# **A1 in Northumberland: Morpeth to Ellingham**

**Scheme Number: TR010041**

## **6.8 Environmental Statement – Appendix 10.4 Drainage Strategy Report**

**Part B**

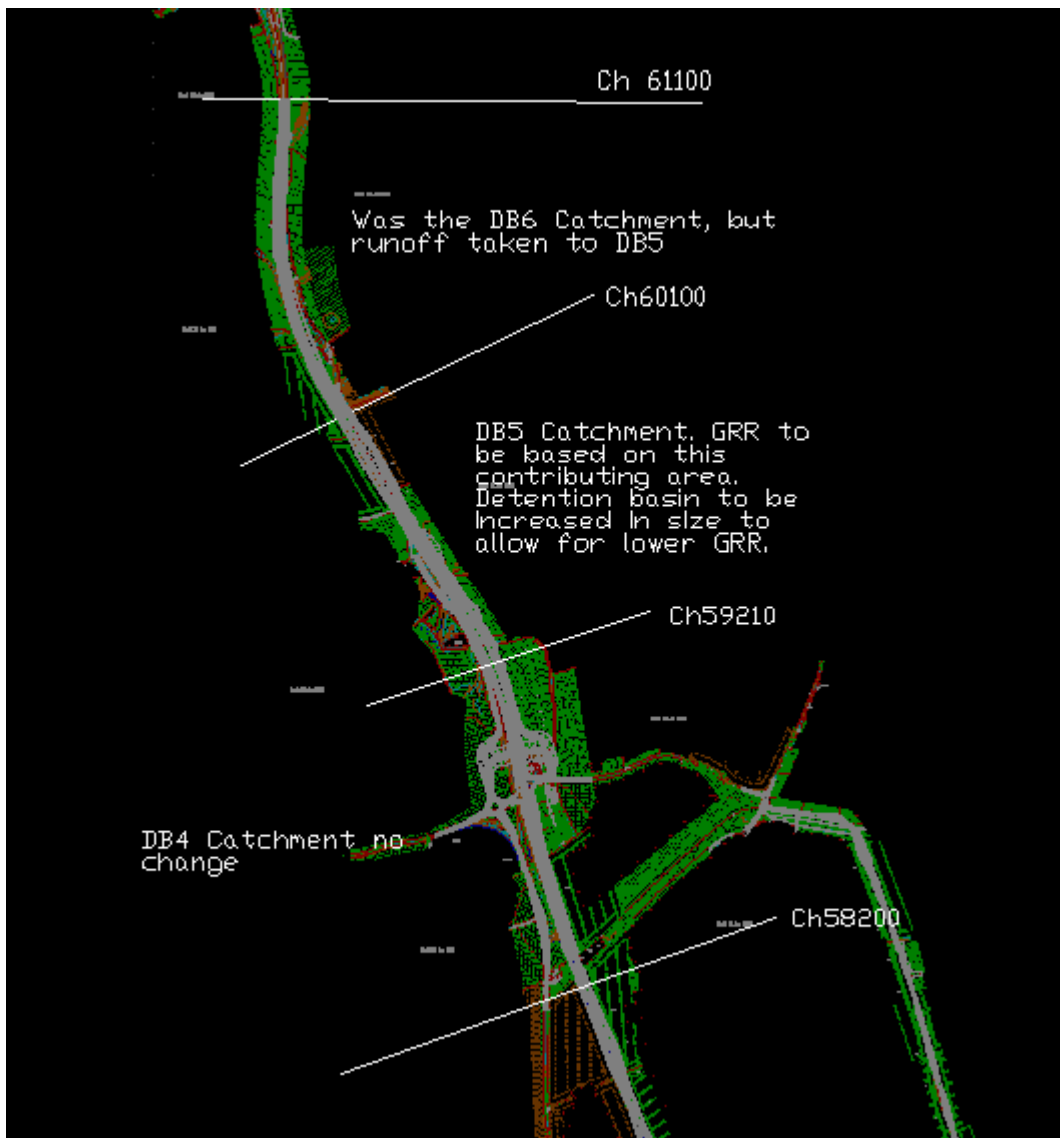
We are proposing to remove Detention Basin 6 and divert flows to Detention Basin 5 in order to remove the need for a detention basin within the same field as a Scheduled Monument is located. The Scheduled Monument is a prehistoric burial mound of national importance which, by its nature, could have additional artefacts associated with the Scheduled Monument located outside the boundary shown on Historic England mapping (<https://historicengland.org.uk/listing/the-list/list-entry/1018499>). Detention Basin 6 is located outside of the Scheduled Monument boundary but the construction of the basin could cause disruption and damage to archaeological remains extending beyond the Scheduled Monument boundary. In addition, during operation there could be changes in water levels due to the presence of the detention basin which could lead to the decay of the archaeological remains associated with the Scheduled Monument. Therefore, the preference would be to remove the detention basin from the field with the Scheduled Monument in order to avoid these potential impacts.

Explanation acceptable - Please include this within any formal surface water drainage strategy documentation that is to be submitted.
